FREDERICK COUNTY HISTORIC PRESERVATION COMMISSION

STAFF REPORT

Address: 1320 Old National Pike, Middletown **Meeting Date:** August 4, 2021

Proposal: Add one-story addition to rear

Fig. 2: Existing Floor Plan and Proposed New Floor Plan

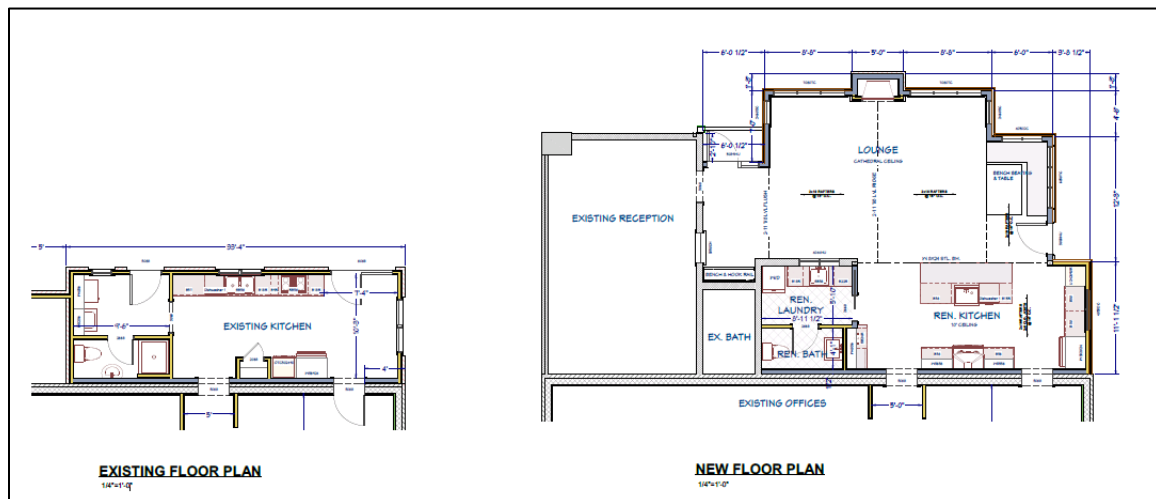
The proposed addition is located to the rear of the property and is inset 3' 8 ½" from the existing circa 1950 addition. The proposed addition will extend 12' 3" off the existing rear addition. Because the property is located at an intersection, the rear of the property is visible from both Old Hagerstown Road and Old National Pike. The addition will be attached to the existing addition that has no significance to the property and will cover a portion of the rear two-story wing. The proposed gable roof will reach the second story of the main block but the peak will not extend above the roof cornice.

Staff finds that the proposed addition would be appropriate and compatible to the massing, size, scale, and architectural features of the historic house with the following changes:

- a. The windows should not be paired together but spaced individually so that they match the rhythm of the existing windows.
- b. The windows should have multiple, true divided lights.
- c. The height of the stone veneer base should be lowered so that it does not reach the bottom of the window openings. It should match the overall heights of the stone foundation on the exiting house.
- d. The exterior wall cladding should be smooth cement boards.
- e. The doors should not contain full lights but be compatible with the existing doors.

- f. Vegetation to partially screen the addition from being highly visible from Old Hagerstown Road and Old National Pike should be installed.
